**Before the Expert Panel appointed
under the Fast-track Approvals Act 2024**

an application for approvals by Mt
Iron Junction Limited to develop 250
medium to high density residential
dwellings, a childcare centre, a retail
building, a café, reserve areas and
recreation amenities

**Statement of Evidence of
Andrew David Carr on behalf of
Mt Iron Junction Limited in response to
comments made under Section 53**

Transport

**Figure 3: Potential Tie-In to Existing Shared Pathway 50m from Underpass
(Source: Google Streetview)**

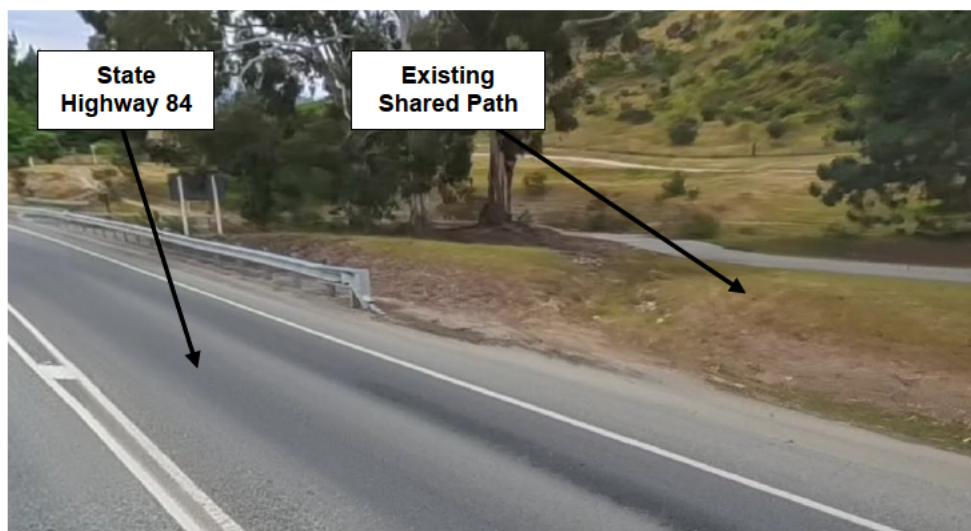
49. Approximately 50m east of the existing underpass, an existing shared pathway runs close to the legal highway boundary. It would therefore be possible to link the proposed shared pathway into this.

51. However, I also highlight that this is only one option, and that it would also be possible to construct part of this shared path within the legal highway reserve, say between the old legal road as far as Puzzling World, and then tie it back into the existing Mt Iron Trail. The latter would then need to be improved between this connection and the underpass to provide a better level of service (such as widening the path, improving the surface and removing steep grades).

50. On this basis, it does not appear that there are any technical or design impediments to forming this shared path. I have been provided with an indicative cost of approximately \$250,000 for providing a 3m wide shared path in the manner described above over this 1.1km length.

Figure 7: Car Entering 2.65m Wide Space and 6.5m Aisle (Dimensions Interpolated between District Plan Values)

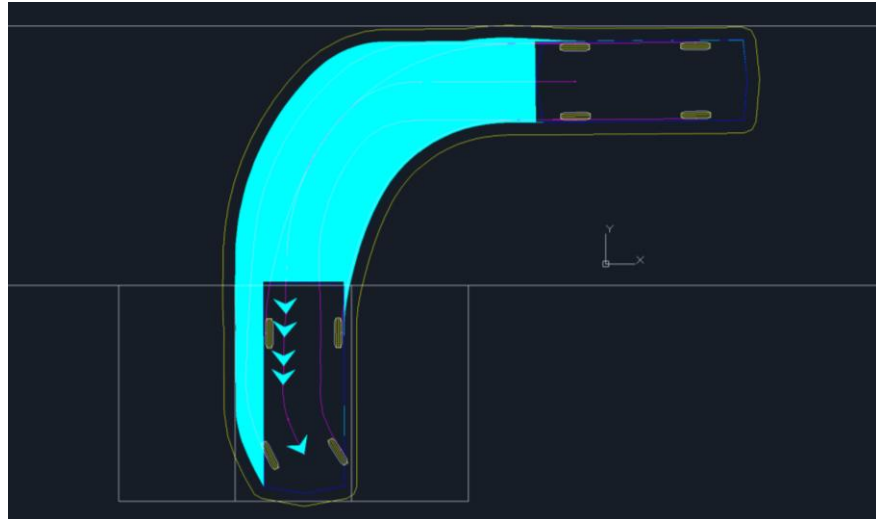
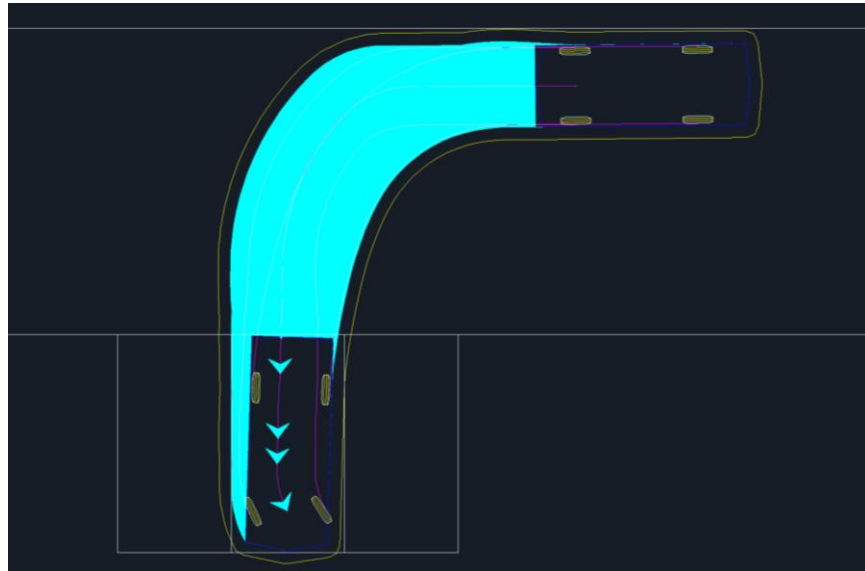
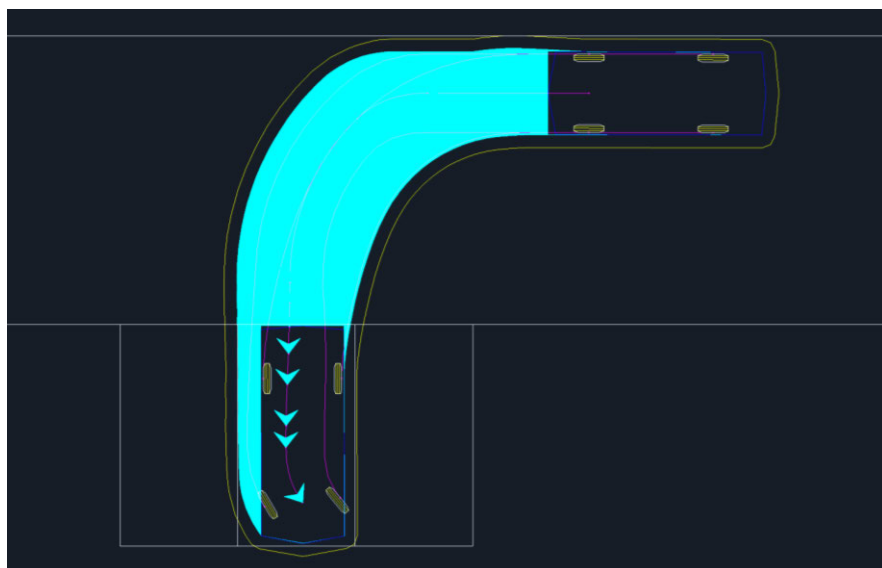
64. Within Section 5.2.1 of their report, Stantec comments on the size of car parks, and highlights a difference between the provisions of the PDP and that of the overarching national Standard AS/NZS2890.1:2004. I agree with the description of the differences. I am aware of the revision to the Standard, although as work is on hold, draft updates can be given no weight. Rather, the approach taken within the Transportation Assessment (Appendix K) was to use the dimensions of car parking spaces as set out in the PDP.

65. In a small number of cases, the approach taken was to interpolate between the PDP values for the width of the spaces and width of the aisles to conclude that intermediate values were supportable (Transportation Assessment (Appendix K), paragraphs 7.3.1.9 and 7.3.6.5) and Stantec queries this approach (Stantec Section 5.2.1). Unfortunately, in promulgating their *reductio ad absurdum* argument, Stantec *extrapolates* the widths of the parking spaces. In that respect, I agree with their position that if parking spaces become wider then there is a limit to how much the aisle width can reduce. However that is not the question to hand – the issue is that if, say, the PDP allows spaces to be 2.6m wide with an aisle of 7.0m, and 2.7m wide with an aisle of 6.0m, is it reasonable to *interpolate* dimensions mid-way between these (that is, a 2.65m wide space with a 6.5m aisle)?

67. These Figures show that a space that is of intermediate dimensions can easily be driven into by a car. By way of further assessment, I have measured the clearance between the car bodywork and the edge of the space as the vehicle enters enter:

- (a) 2.6m wide space and 6.0m aisle (PDP dimensions): 0.04m.
 - (b) 2.7m wide space and 7.0m aisle (PDP dimensions): 0.15m.
 - (c) 2.65m wide space and 6.5m aisle (interpolated dimensions): 0.10m.

68. The clearance for the interpolated dimensions of the space falls halfway between the values for the PDP spaces. This is as would be expected if there is a linear relationship between the widths of the spaces and widths of the aisles.

69. I therefore do not agree with Stantec's conclusion that "*a linear relationship does not exist in practice*" because the data demonstrates that it does. Irrespective, the argument is somewhat arbitrary as the outcome through the tracking is clear that such spaces can be accessed in practice.

**Figure 8: Examples of Potential Locations for Cycle Parking (Red Dots)
(Extract From Engineering Drawings Sheet 300C)**

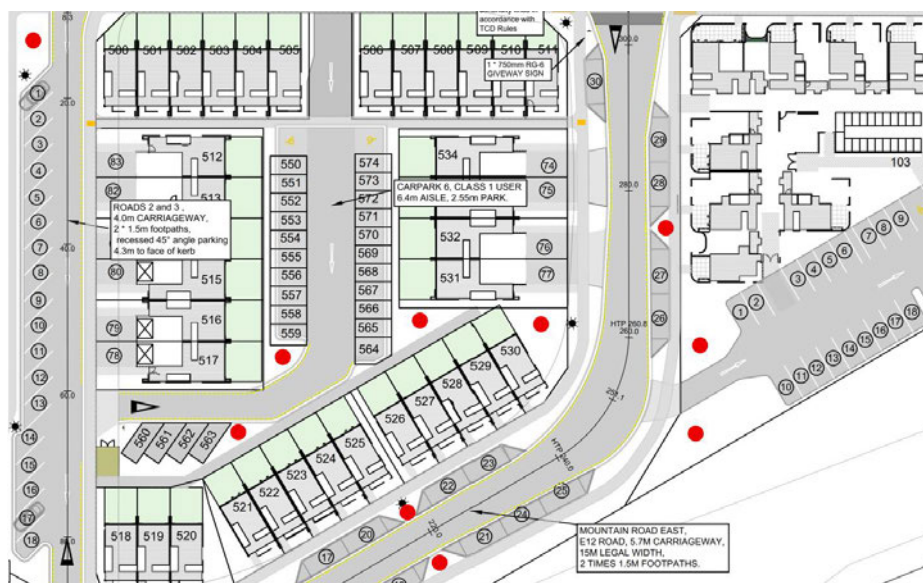
73. In Section 5.2.3 Stantec also comments that no specific storage locations are provided for cycles and considers this to be a "*poor design outcome*". Stantec draws comparisons with the provisions for residential cycle parking in the Te Pūtahi Ladies Mile Zone within the PDP, and I consider that this is a helpful approach. The PDP provisions in this regard are set out in Table 29.6, where it is noted that residential units in the Te Pūtahi Ladies Mile Zone require 1 cycle parking space, and 1 space for visitors is required per 20 units. Under Note 29.10.17, these can be provided within garages or communal cycle storage sheds.

74. For the Project, cycle storage is anticipated within the garages at Unit Types A to C. Unit type D have covered areas adjacent to the ground floor living rooms and have outdoor space that could be used for a cycle storage shed. The ground floor area of the apartments (Type E units) have dedicated ground floor lockable storage areas for cycles (shown on Sheets A1.39 and A1.59 of the architectural plan sets, and included as Appendix C1 to the application). Each apartment block has at least one cycle parking space per unit (in passing, I note that the plans show that cycles are stored with both wheels on the ground but additional cycle parking could be provided by a 'hanging' type of system).

75. On this basis then, at least one cycle parking space is available for each residential unit.
76. With 250 units, a total of 13 cycle parking spaces is required for visitors. Because the residential development extends for a distance of over 400m through the Site, I do not consider that providing one communal area for visitor cycle parking is a practical solution. Visitors will seek to park their cycle close to the unit that they are visiting and so a centralised parking area is unlikely to be well-used. However, there are numerous locations where a cycle stand could be provided within the road reserve, which would lead to an outcome of stands conveniently located throughout the Site. Examples of possible locations are shown below.

77. On this basis I consider that ample cycle parking is provided within the Site, and there are no reasons to anticipate that the uptake of cycling would be suppressed through a lack of cycle parking in the Site.
